# Body and Equipment Guideline (BEG)

## Addendum

Sprinter 2019 – Model Designation 907

**Addendum Topic: Non-drilling/modification areas**

Figure 1 Safety and crash relevant areas (marked in blue)

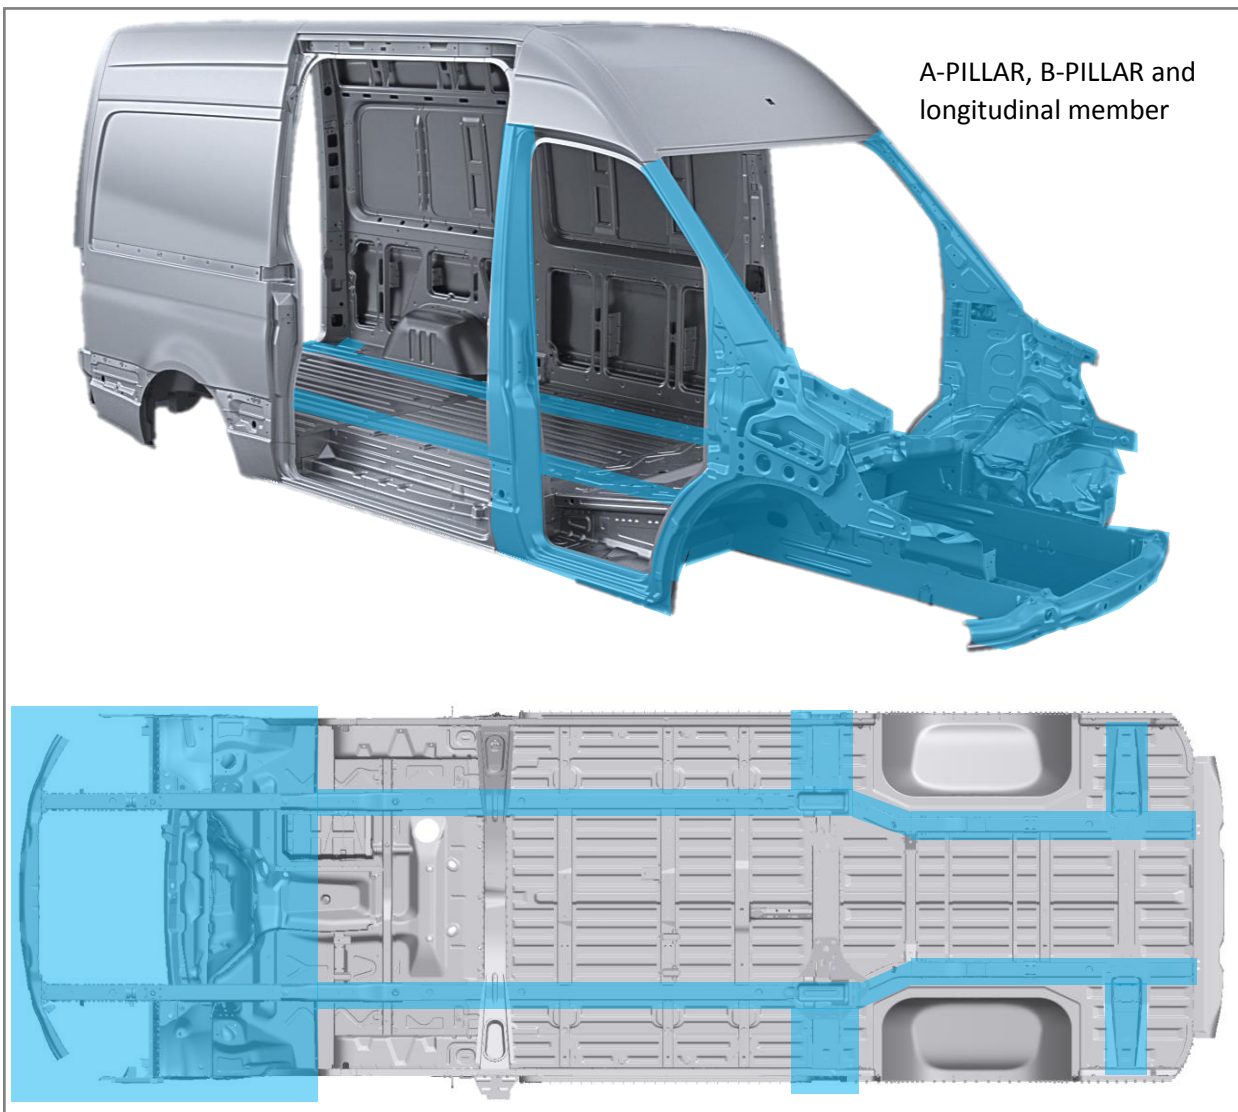
This chapter provides information about areas which should **not** be modified or changed due to safety and crash reasons

Mercedes-Benz recommends not to drill into the marked areas. For further information please review the BEG.

The following pictures show the safety and crash relevant areas.

Figure 2 Longitudinal member, non-drilling areas

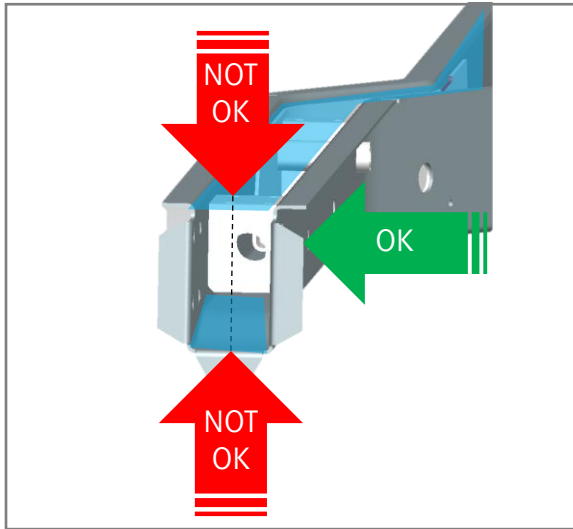
Figure 2 shows where drilling into the longitudinal member is not allowed.

Drilling must not take place:

- The A and B-pillars
- Mounting parts on the rear of the B-Pillar without harming the integrity of the structure is permitted
- For Mounting of Partition Walls please use existing holes
- In the upper or lower flange of the longitudinal framemember
- In the vicinity of load application points (e.g. springbrackets)
- In the vicinity of front axle or rear axle supporting points
- In the vicinity of the airbags

Figure 3 Front lifting points

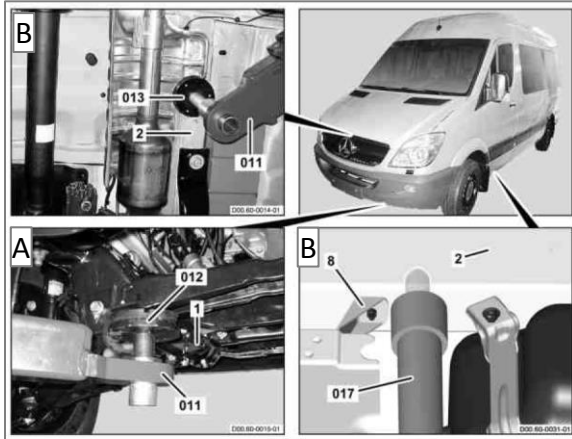
This chapter provides information about the location of the lifting points in the front part of the underbody.

Figure 4 Front underbody non-drilling areas

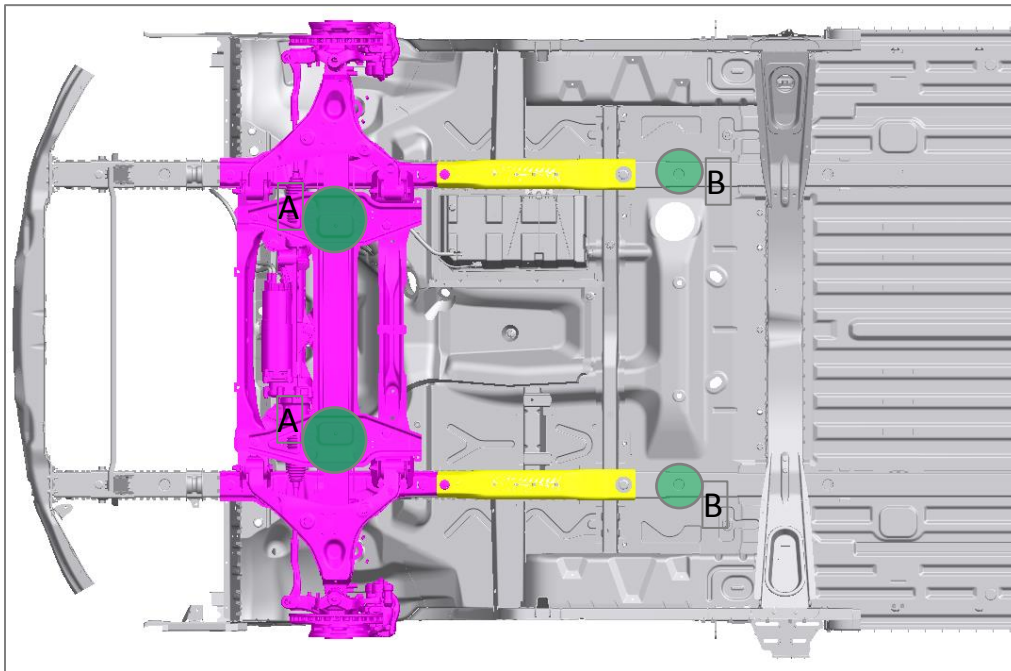
- Vehicles which have been modified in areas of maintenance points/lifting points are not maintainable at Mercedes-Benz dealerships.
- Due to safety reasons Mercedes-Benz dealerships will not use any other lifting points than the designated by Mercedes-Benz standards (see above).
- Mercedes-Benz highly recommends not to modify the highlighted areas.

Figure 5 Rear lifting points

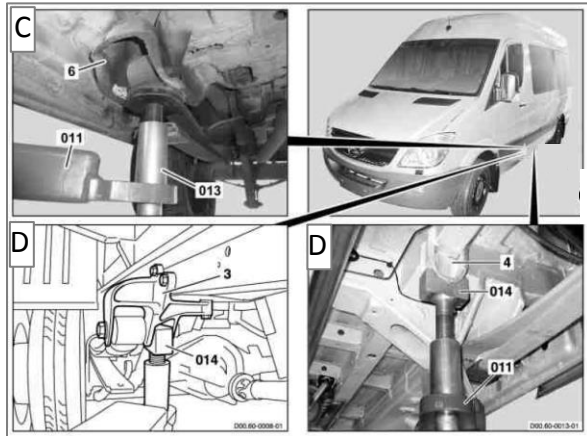
This chapter provides information about the location of the lifting points in the rear part of the underbody.

Figure 6 Rear underbody non-drilling areas

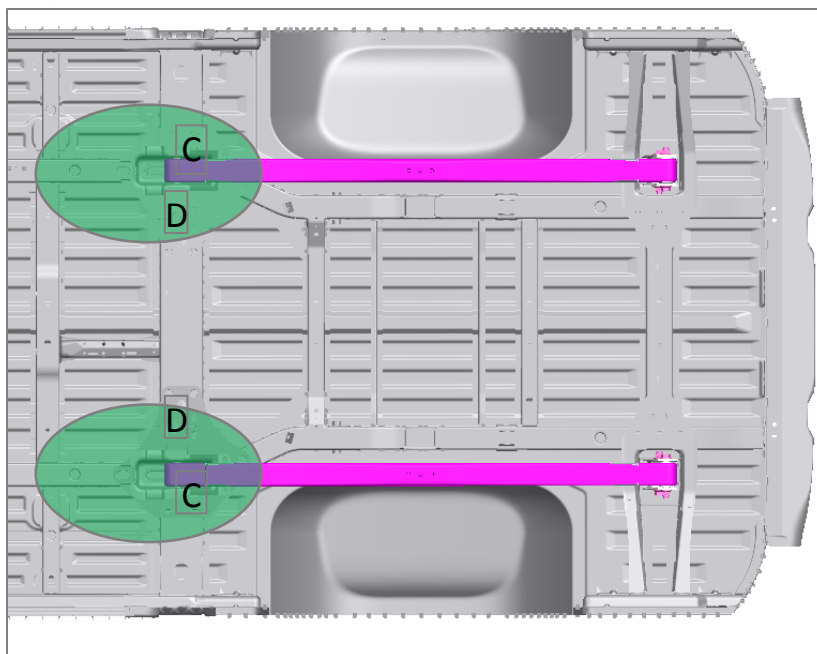
- Vehicles which have been modified in areas of maintenance points/lifting points are not maintainable at Mercedes-Benz dealerships.
- Due to safety reasons Mercedes-Benz dealerships will not use any other lifting points than the designated by Mercedes-Benz standards (see above).
- Mercedes-Benz highly recommends not to modify the highlighted areas.
